CITY OF PORTSMOUTH PLANNING DEPARTMENT

MEMORANDUM

Subject: Staff Recommendations for the May 16, 2019 Planning Board Meetings

Date: 05/13/19

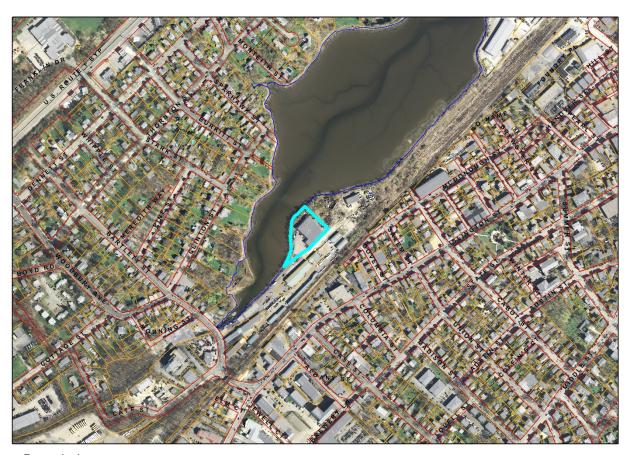
- 4.1) Applicant shall work with DPW to finalize the location and design of the lighting conduit layout.
- 4.2) Applicant shall provide fair share contributions to the City as follows:
 - a) Sewer infrastructure improvements on Raynes Avenue and Vaughan Street
 - b) Russell Street / Market Street Intersection Improvements
 - c) Deer and Maplewood Avenue Intersection Improvements to Traffic Signal
- 4.3) Plans shall be reviewed and updated for consistency with the Maplewood Avenue Complete Streets Project Preliminary Engineering Plans subject to final approval by the Planning Director.
- 4.4) Sheet C-102.3 shall be updated to note that the arrows shown on the plan shall be painted on the pavement surface to help guide motorists in the proper direction.
